## Product Change Notification (PCN)

**Products affected:** 090-3-004-0-F-XR1-1430-1150-0740-0280A37  
090-3-012-0-F-XR1-1430-1150-0740-0280A37

**Description of part:** Pin Header SMD 2,54 mm, Double row

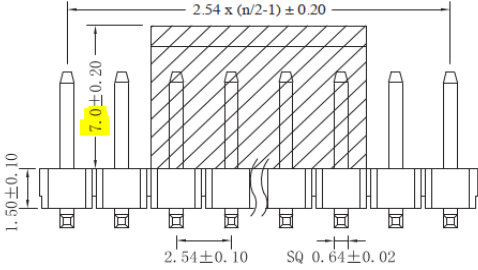
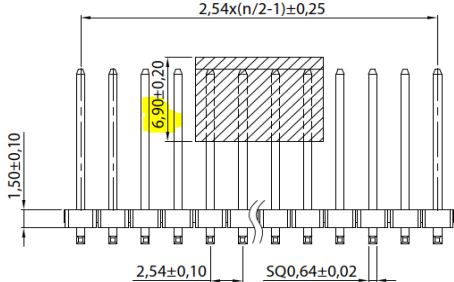
**Description of change:** several dimensional changes

**Reason for change:** revision of tooling

Variant	old version	new version												
090-3-004-0-F-XR1-1430-1150-0740-0280A37 and 090-3-012-0-F-XR1-1430-1150-0740-0280A37	 <table border="1" data-bbox="464 909 678 976"> <tr> <td>Cap length</td> <td>L</td> </tr> <tr> <td>pincount <math>\leq 8</math></td> <td>5,08 mm</td> </tr> <tr> <td>Pincount <math>&gt; 8</math></td> <td>10,0 mm</td> </tr> </table>	Cap length	L	pincount $\leq 8$	5,08 mm	Pincount $> 8$	10,0 mm	<p>see yellow marked dimensions</p>  <table border="1" data-bbox="1024 898 1161 965"> <tr> <td>Pincount</td> <td>A</td> </tr> <tr> <td>004</td> <td>5,0</td> </tr> <tr> <td>012</td> <td>10,0</td> </tr> </table>	Pincount	A	004	5,0	012	10,0
	Cap length	L												
	pincount $\leq 8$	5,08 mm												
Pincount $> 8$	10,0 mm													
Pincount	A													
004	5,0													
012	10,0													
	<p>see yellow marked dimensions</p> 													
 <p>P.C.B. LAYOUT</p>	<p>see yellow marked dimensions</p>  <p>P.C.B. LAYOUT</p>
